### **REMARKS**

Applicant submits herewith Annotated Marked-up Drawings for the Examiner's approval, containing proposed drawing corrections, and proposed Replacement Sheets for drawing sheets 5 and 6.

**In the Drawings:**

Annotated Marked-Up Drawing  
for Examiner's Approval

FIG. 7

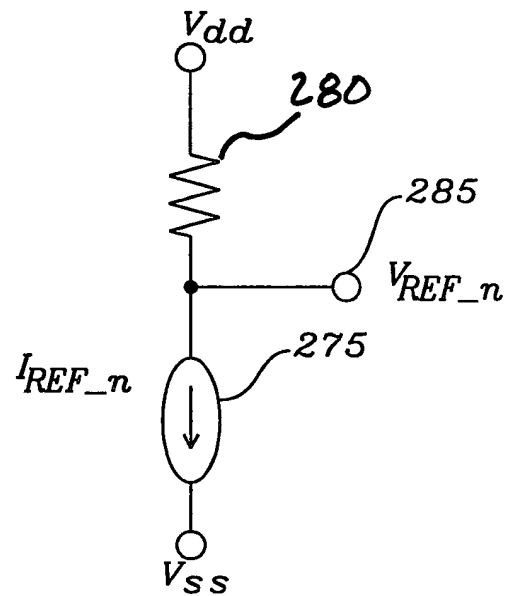
Paragraph 42 of the specification refers to a reference resistor 280, but the resistor in Figure 7 was unnumbered. Applicant proposes adding a reference number 280 and lead line to Figure 7.
